# ROCKY FLATS SITE

## REGULATORY CONTACT RECORD 2015-01

**Purpose:** Reportable condition for uranium 12-month rolling average at Point of Compliance WALPOC (this Contact Record supersedes RFLMA CR 2014-10)

Figure 1

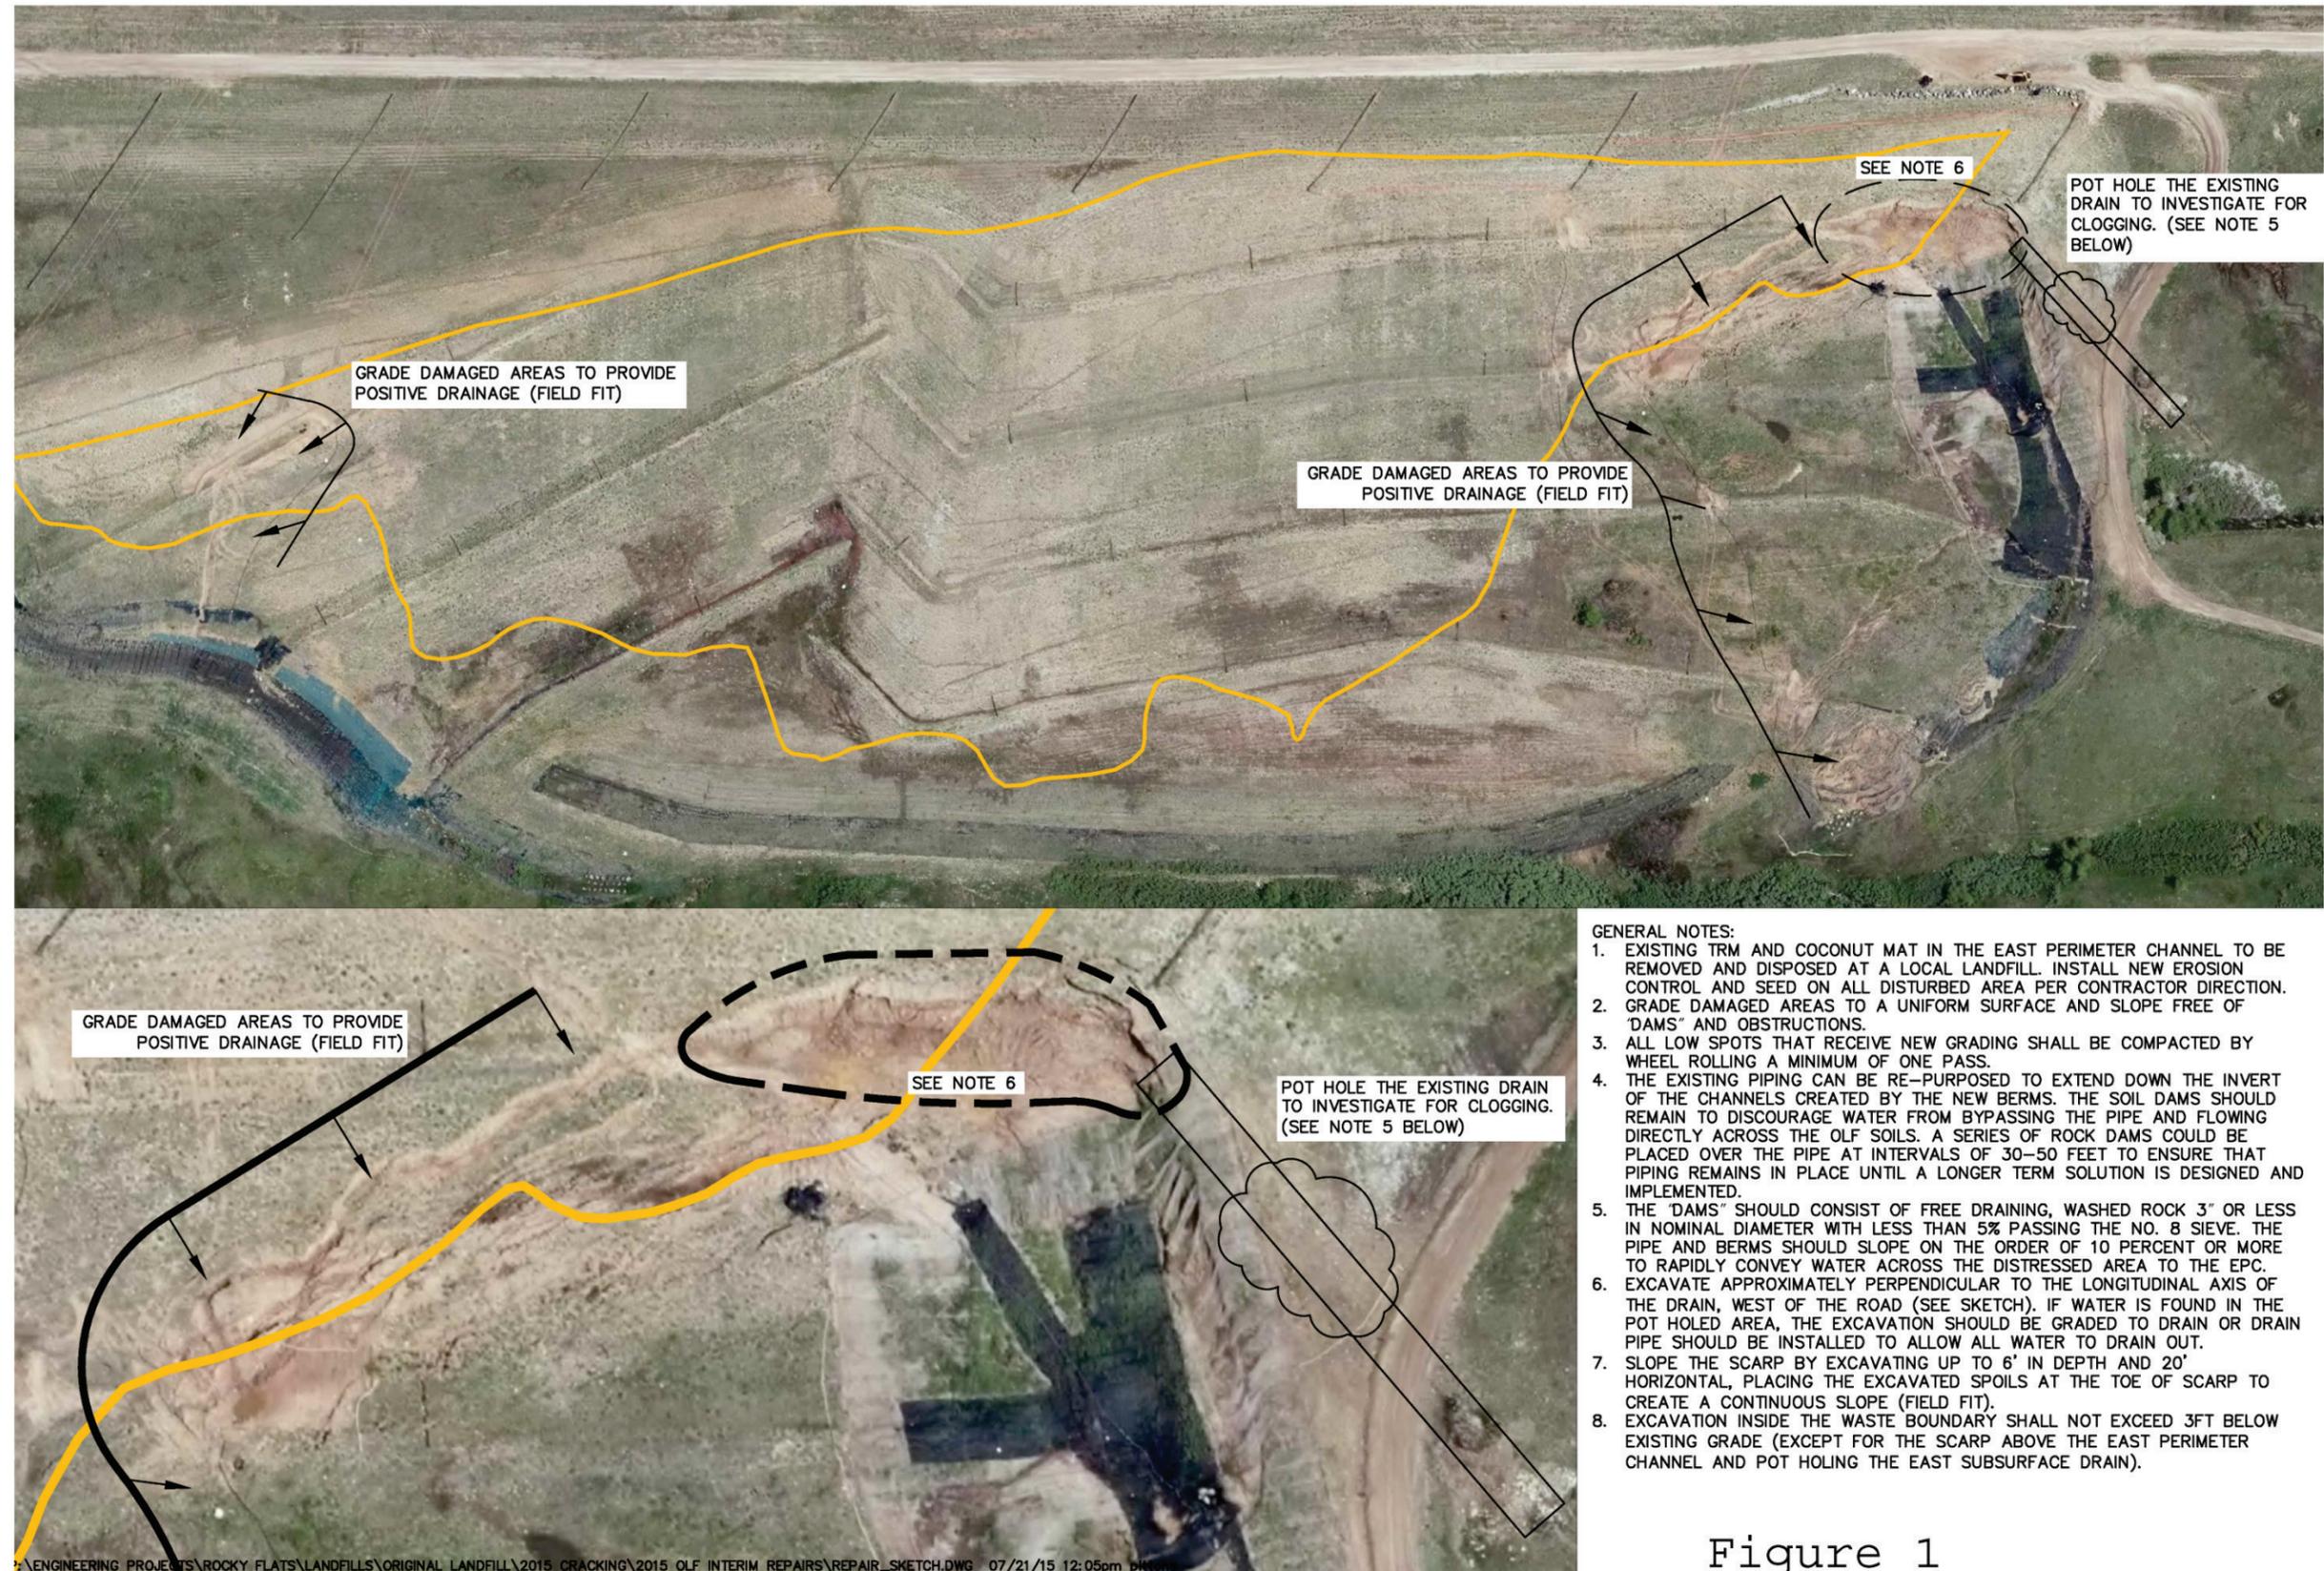
The area near the northeast edge of the OLF cover, where a rock drain was installed as a part of the OLF closure project, is very wet at the ground surface (see Figure 1). Observations by Rocky Flats staff and exploration using an excavator have shown that this drain appears to be at least partially blocked or clogged, hampering its effectiveness. The wet ground suggests the drain may be full of water that feeds permeable, low-strength lenses in the shallow soils. Excavation in the area to try to provide an outlet for water that may be collecting in the buried rock, thus providing a water source to the distressed areas, will be completed and will require an excavation of approximately 25 feet.

Although distress has been less extensive on the western side of the OLF, local instabilities and distress have been noted (see Figure 1). These areas will be mitigated in a similar manner for the short term (but will not require intrusive work focusing on a subsurface drain, as planned on the eastern side). Scarps, hummocky surfaces, and other slope irregularities can be smoothed and drain pipes installed to more rapidly convey water across the distressed areas until the subsoils have dried and a longer-term solution has been designed.

Contact Record (CR) 2015-06 Figure 1 shows the location and the lateral extent of the planned regrading, excavation, and soil disturbance. Laying back the largest scarp to achieve a shallower and more uniformly sloping configuration will require a cut of approximately 6 feet. Regrading the face of the cover as noted on CR 2015-06 Figure 1 will require a 3-foot cut at the edge of the waste footprint and in the EPC. The pothole indicated on CR 2015-06 Figure 1 will be approximately 25 feet deep.

**Resolution:** CDPHE, after reviewing information regarding the proposed soil disturbance and excavation and after consultation with EPA, will approve, approve with modification, or disapprove the proposed activity. CDPHE will determine whether the proposed activity: (1) will not compromise or impair the function of the remedy or (2) will result in an unacceptable release or exposure to residual subsurface contamination. CDPHE will also determine whether the proposed project meets the rationale and objectives of IC 2, 3 and 6.
